**V2500-A1 SERIES PROPULSION SYSTEMS SERVICE BULLETIN**

This document transmits Revision 3 to Service Bulletin V2500-ENG-72-0150

**V2500-ENG-72-0150**

### ENGINE - LP COMPRESSOR - PROVIDE A NEW WEIGHT REDUCED FAN FRAME ASSEMBLY AND ASSOCIATED DETAILS

Fan Frame Assembly and Associated Details - After Alteration  
Figure 2 (Sheet 1 of 3)

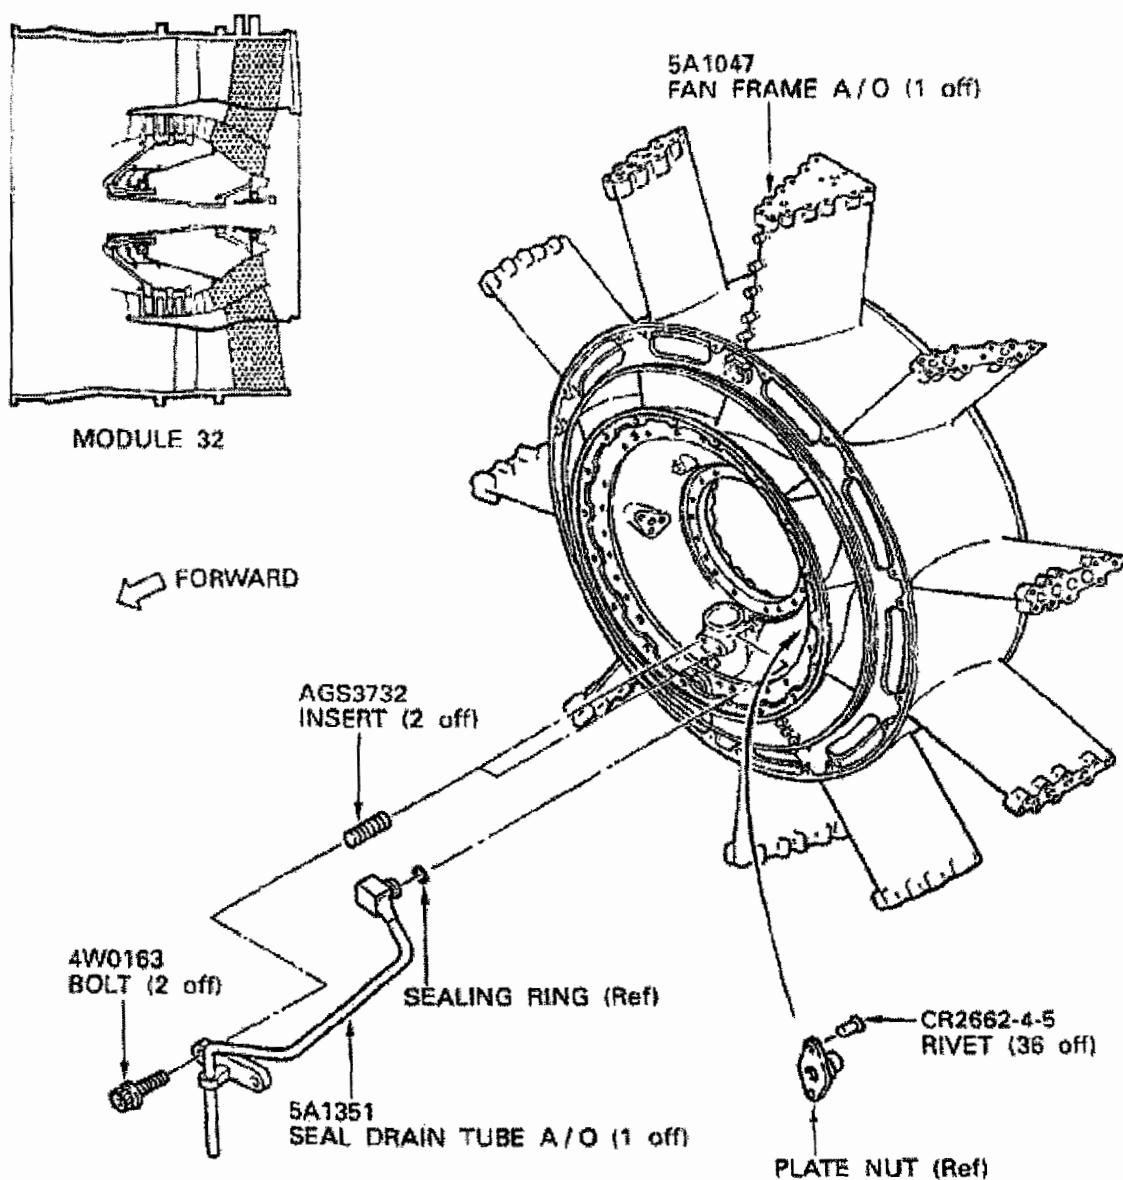
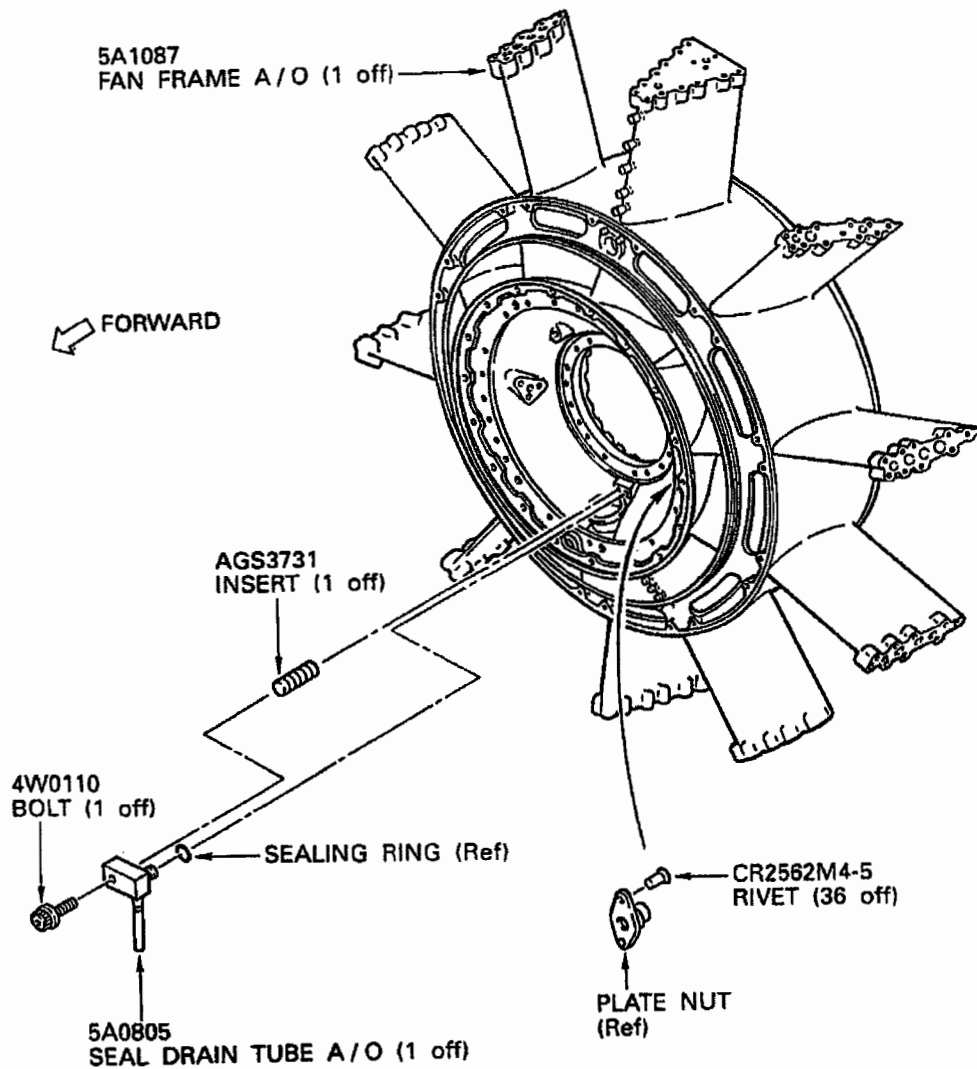
- (a) The Removal/Installation and Disassembly/Assembly will be revised due to new configuration of the fan frame assembly, the rear drain tube and the thrust mount brackets.
- (b) Cleaning, Inspection/Check and Repair will be revised due to new configuration of the fan frame assembly.

- (a) A new fan frame assembly which has the reduced wall thickness and optimized frame shape has been introduced.
- (b) A design features of anti-rotation for mount tube stopper has been changed to improve the durability of rubber securing features.
- (c) The new seal drain tube which has the revised attaching feature and re-routed tube has been introduced.
- (d) The new thrust mount brackets which have the thicker platform and larger size of attaching bolts has been introduced.
- (e) The new assembly module part number, 5W0153 of LP Compressor/Intermediate Case Module have been introduced.

- (b) Install the two 4W2326, screws and the two 4W0001, nuts. Torque the nuts to 36 to 45 lbfin (4,00 to 5,00 Nm).
- (3) Install the 5A0805, seal drain tube to the 5A1087, fan frame assembly as follows (Refer to Figure 2, Sheet 1 of 3.):

- (a) Lubricate a new sealing ring with CoMat 10-077, approved engine oils. Install the sealing ring in to the groove on the Seal drain tube.
  - (b) Install the seal drain tube in to the connection of the fan frame assembly. Safety with the 4W0110, bolt and torque it to 36 to 45 lbfin (4,00 to 5,00 Nm).

Reidentification of the New Module Identification Plate  
Figure 3

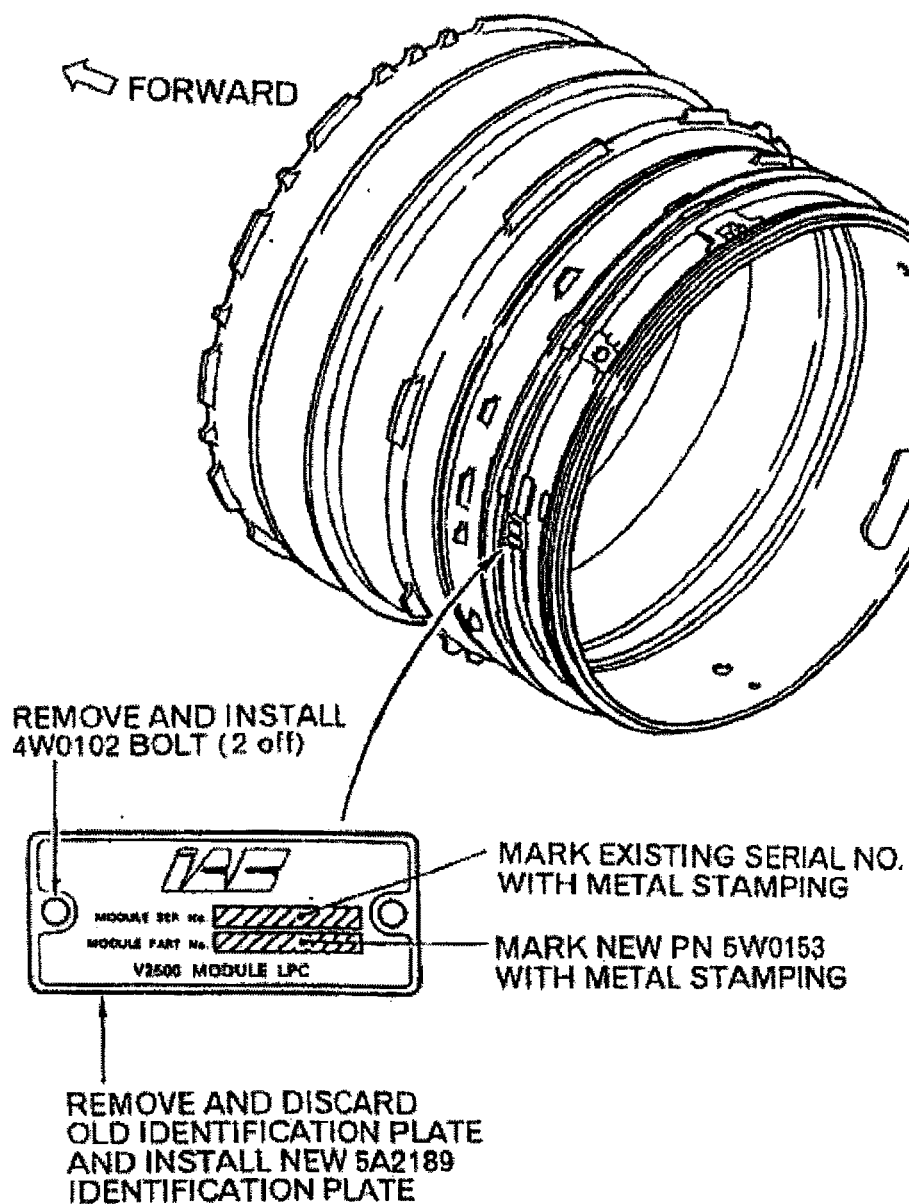
- (d) Torque the bolts to 450 to 525 lbfin (51,0 to 59,0 Nm).
- (5) Install the new 5A2189, Module Identification Plate as follows (Refer to Figure 3):

- (a) Find the existing 5A2189, Module Identification Plate on the LP Compressor/Intermediate Module and make sure that the module part number is 5W0142.

(b) Replace the existing module part number 5W0142 with the new number 5W0153 as follows;

1. Remove the existing two 4W0102, Bolts from the existing 5A2189 Module Identification Plate on the Fan Case.
2. Remove and discard the existing Module Identification Plate.

3. Make a mark of the module part number 5W0153 and existing serial number on the new 5A2189, Module Identification Plate by the approved procedures in Reference (3), Chapter/Section 70-09-00, Marking of Parts.
4. Install the newly marked 5A2189, Module Identification Plate with the two 4W0102, Bolts at the sufficient position.
5. Torque the bolts to 36 to 45 lbin (4,00 to 5,00 Nm).
